Public Review of More Proposed Addenda Updates to SGM-SF

(Soil Gas Mitigation Standards for Existing Homes)

Public Review: SGM-SF Addenda 26-8
COMMENT DEADLINE: July 27th, 2026

EXHIBIT 6.2.9 Freeze-up (wet climate zones)

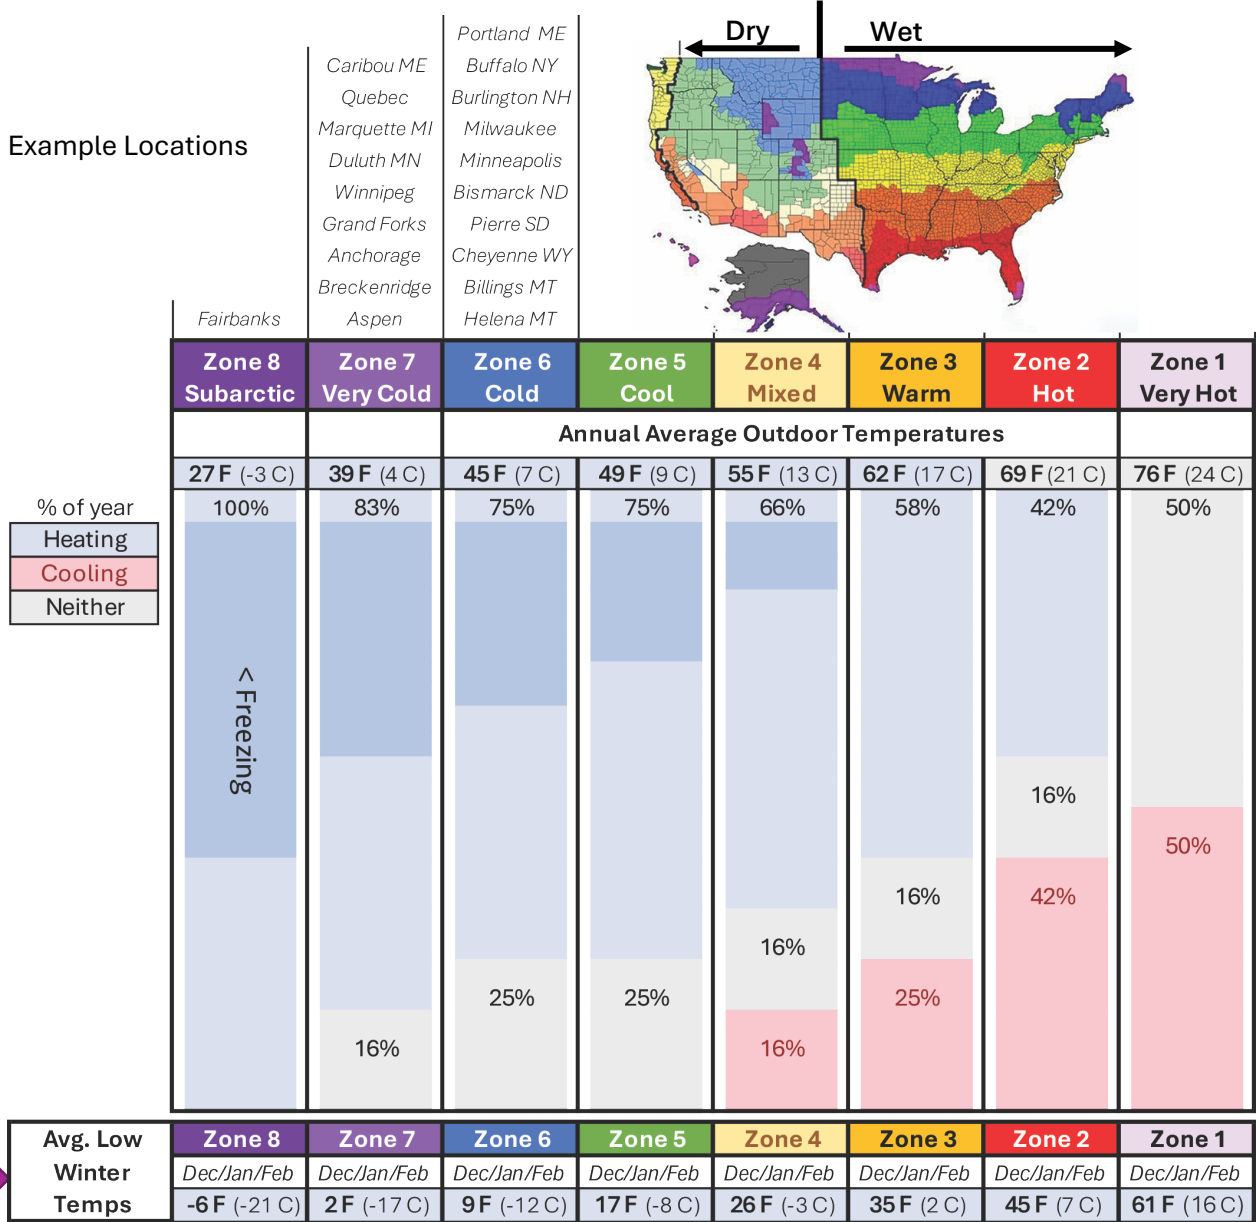
For wet and cold climate zones 6, 7, and 8, as identified in Exhibit 6.2.9, the proposal in Section 4.2 (Proposals) shall disclose the potential for ASD systems to freeze up due to ice formation. The proposal shall provide options and associated costs for a design that will inhibit systems from being blocked by ice, such as insulation, electrical heat tape, pipe enclosures that are open to heated areas in the home, increased velocity of discharged air, or other methods.

Elsewhere, duct piping shall be provided with thermal insulation or another solution in accordance with the following two requirements:

- a) Where it is likely on a regular basis (e.g., annually or every few years) that freezing temperatures will result in ice buildup within duct piping that would adversely affect system performance, a solution to inhibit systems ice buildup shall be determined. Where thermal insulation is chosen, the insulation shall be protected from the elements and have an R-value of not less than 4; and
- b) Where it is likely that condensation on exterior surfaces of duct piping would damage building materials, the insulation shall have an external vapor barrier and an R-value of not less than 1.8.

Fig 6.4.1

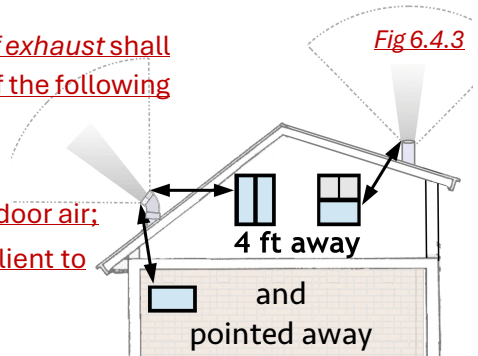
Note—The primary substantive change for this section is removal of exhaust requirement to be 10 ft to the side of operable openings. Relaxing this requirement to 4 ft does however require that the exhaust air be and pointed away from operable openings.

The destination of exhausted soil gas shall comply with all provisions in this Section 6.4. The *stretched-string method* shall be used to measure all distances specified in Section 6.4.

6.4.1.1 The point of exhaust shall be outdoors with soil gas exhausted upward to not deviate more than 45 degrees from vertically upright, except as allowed in Section 6.4.4.

The straight-line path for soil gas exhausted shall be pointed to not encounter any objects or any areas where people could be present within 20 feet (6 m) from the point of exhaust.

Fig 6.4.3

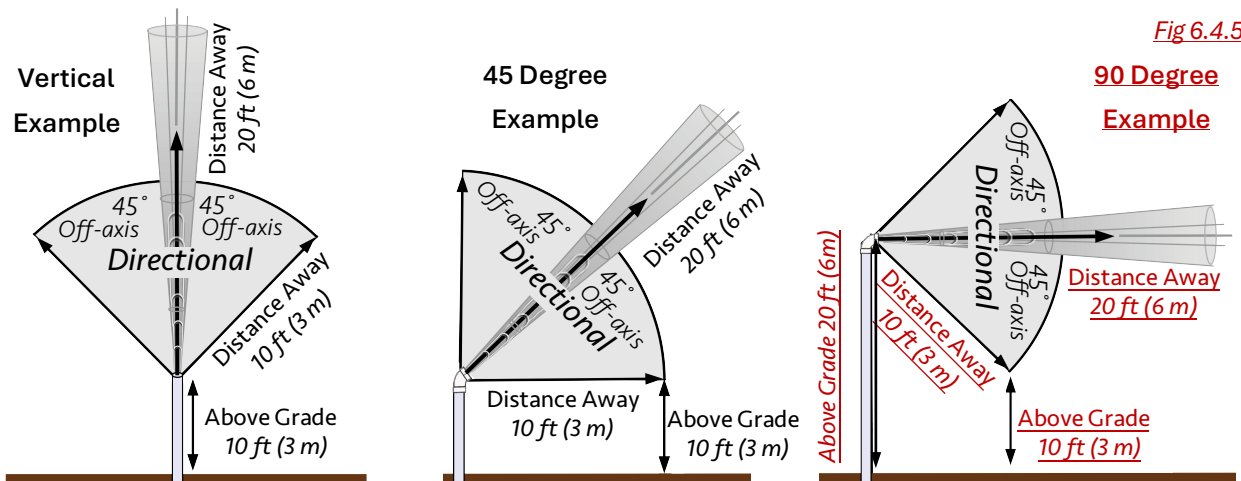
6.4.3 Directional exhaust spread (restrictions)

For the wider 45-degree Directional Exhaust Spread, the point of exhaust shall not be less than 4 feet (1.2 m) away and pointed away from all of the following items that are within 10 feet (3 m) of the point of exhaust:

- a) Operable openings in structures;
- b) Fixed openings intended for ventilating indoor air with outdoor air;
- c) Building materials (except for roof materials that are resilient to damp conditions); and
- d) The breathing space where people could be present.

Fig 6.4.5

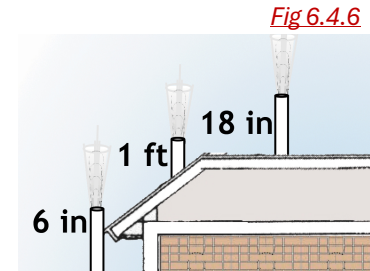
6.4.5 Roof

The point of exhaust shall **not be less than:**

- a) 6 inches (15 cm) above the edge of the roof when ASD piping at the point of exhaust is attached to the side of a building;
- b) 1 foot (30 cm) above a pitched roof at the point penetrated; and
- c) 18 inches (46 cm) above a flat roof.

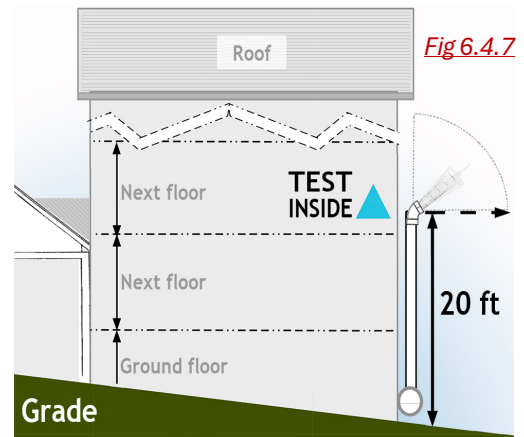
6.4.6 Below the roof

The point of exhaust shall be permitted to be located below the edge of the roof if **compliant** with all other requirements in Section 6.4 **and both a) and b) of this Section 6.4.6.**

a) The reason for placing the exhaust below the roof edge shall be noted in the informational package or OM&M Manual based on either:

- 1. the inability to comply with other requirements of Section 6.4 **if located above the roof, or**
- 2. **the edge of the roof exceeds** 20 feet (6 m) above the nearest grade.
